INDIVIDUAL WATER AND WASTEWATER SYSTEMS PROGRAM
APPLICATION FOR SERVICES

SUBDIVISION OR MOBILE HOME PARK NAME: Castle Gardens

Ref: File 8031A/141B

I have completed the preliminary soil investigation on the remainder of the Castle Garden subdivision located on Robinson Church Road. A soils map of the area was prepared and a copy is enclosed.

PROPOSED PLOT PLAN

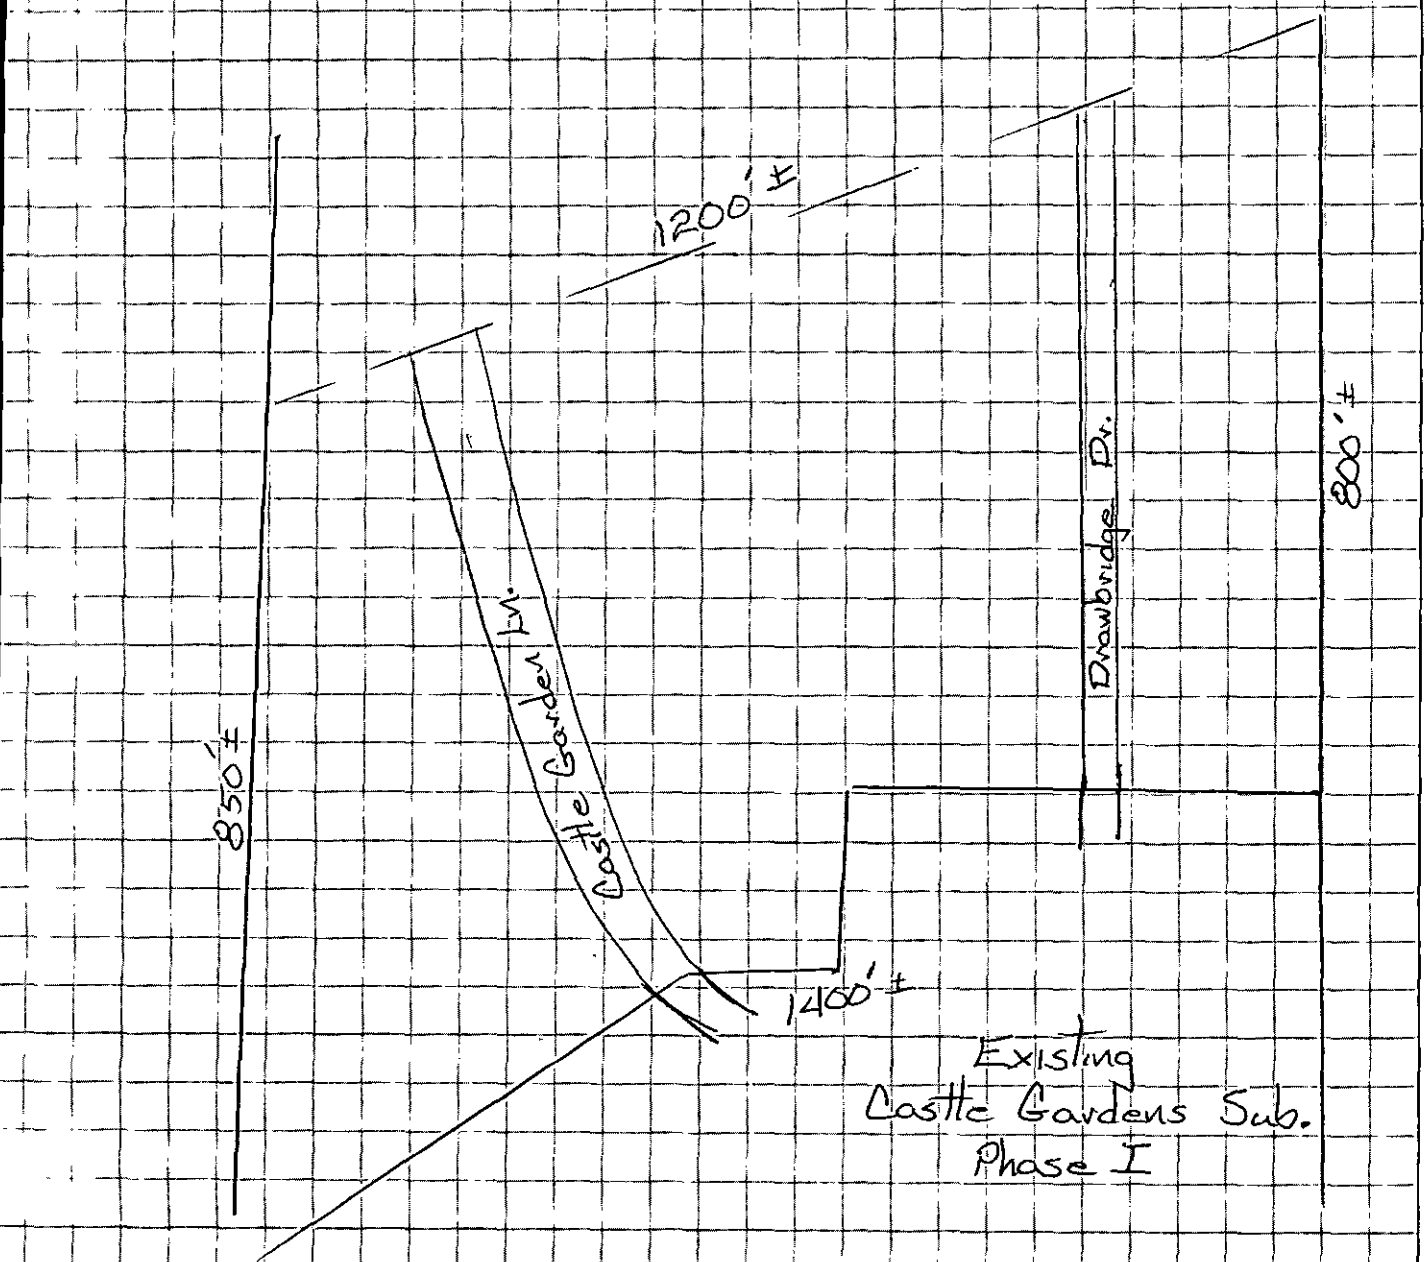
The areas marked with yellow lines on the enclosed map appear to be dominantly unacceptable for the installation of septic tank systems. Included in these areas are mixed soils, complex slopes, and drainage way depression areas.

The mixed soil areas have soils that contain expanding clay minerals in the subsoil horizons. These clay minerals swell upon becoming wet, reducing soil pore space and inhibiting internal soil water movement. These soils show evidence of seasonal perched water at depths of 24 inches or less. Depth to saprolite is generally less than 36 inches. Slopes range to approximately 15 percent but are generally flatter.

Complex slope areas are present on the tract as well. Some pits are found off the proposed Red Wing Road and some old field terraces are also present.

The drainage way - depression areas collect and channel surface water runoff from the surrounding land areas. Some mixed soils described previously are present. Portions of these areas are subject to surface water flooding during periods of precipitation.

The unlined areas appear to be dominantly acceptable for the installation of septic tank systems. These soils have slightly expansive clay subsoil horizons that are blocky with respect to structure. Depth to saprolite and ground water are generally deeper than 48 inches. However, some soils with depths of approximately 24-36 inches were noted in this delineation. This condition appears to be confined to one area, but may not. Additional investigation with established reference points would be necessary to determine the exact situation. Slopes range to approximately 15 percent but are generally flatter.

There is an area that has piled fill material present. A boring around the edge of this material indicated that some soils appearing to be dominantly acceptable for septic systems are present. Additional investigation of this area with the fill removed would be necessary.

Based on this investigation there are soils on the tract that appear to be dominantly acceptable for septic tank system installation. Please note that this report does not express or imply individual lot approval for septic tank system installation. Individual lot approval is dependent in part on the satisfactory completion of soil investigation of the specific lot. Note that lot lines and corners were not marked as of February 24, 1992. Note also that inclusions of soils other than that delineated in a given area may be present.
